**TP310153 ELECTRICAL WIRE ASSEMBLY; TP180904 TERMINAL TAB;
TP180675 SCREW; TP144764, TP176700, AND TP158000 BASES;
ALSO TP199361 MODIFICATION KIT**

APPARATUS AFFECTED: 28A, 28B, 28D, 28E, 28F, 28G, 28G-1, 28H, 28J, 28J-1, 28K Perforator-Transmitter-Bases; TP144764, TP176700, and TP158000 Bases; TP199361 Modification Kit.

SECTION 573-117-800.29

Fig. 1 — TP144764, TP176700 or TP158000 Base

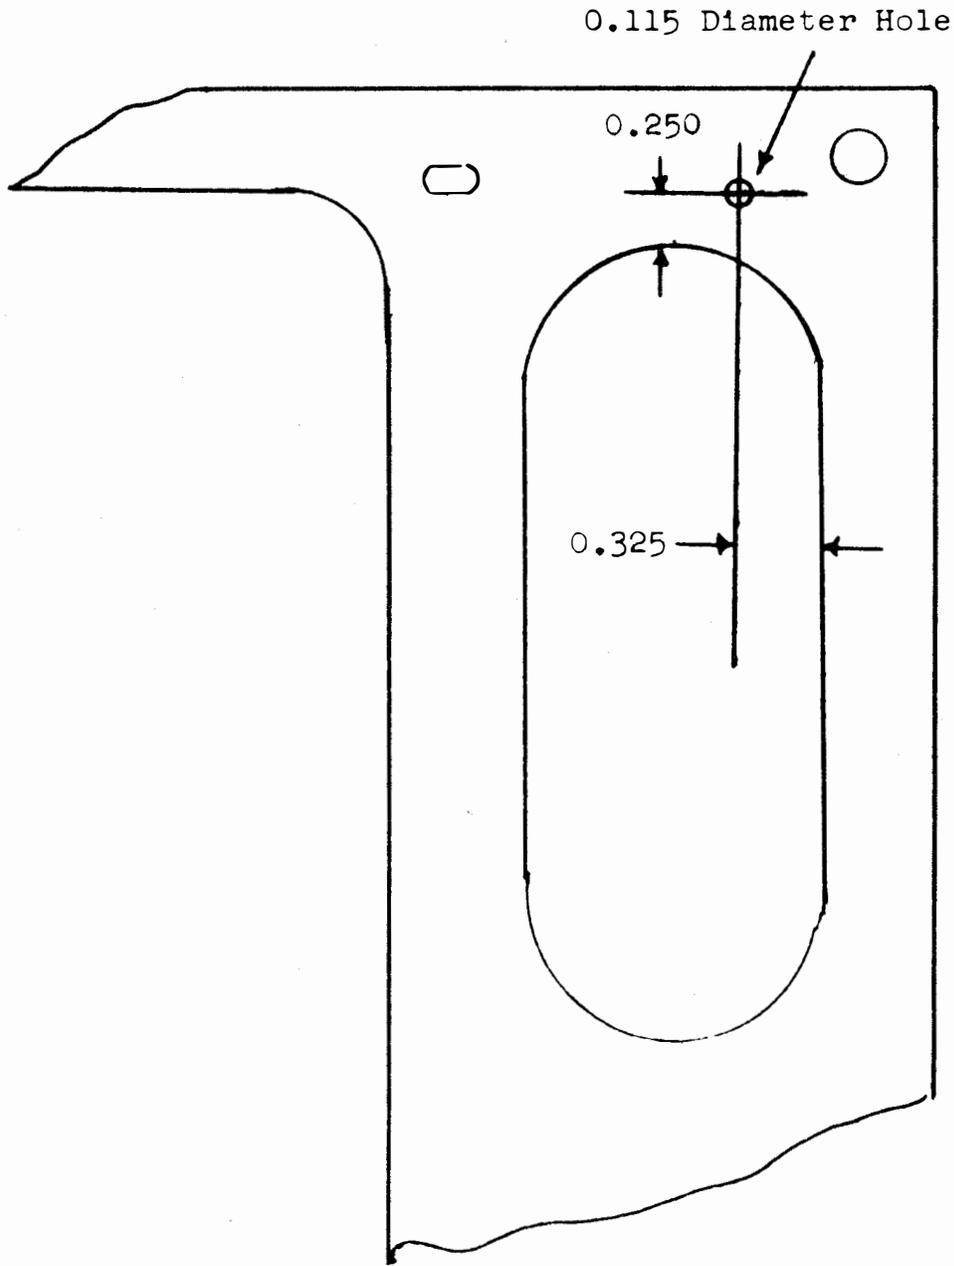
CHANGE: The TP144764, TP176700, and TP158000 bases have been modified by the addition of a 0.115 diameter hole (adjacent to the lower left motor mounting screw) for mounting a terminal tab by means of a self-tapping screw. See Figure 1.

The TP151569 ground strap connected between the TP158196 right base rail and the cabinet has been replaced with a TP310153 wire assembly consisting of 15 inches of No. 18 wire (green) equipped with a closed type lug on one end and a push type lug at the other end. The closed type lug mounts on the TP158682 plate (cabinet frame ground). The push type lug mates with the new TP180904 terminal tab mounted on the base.
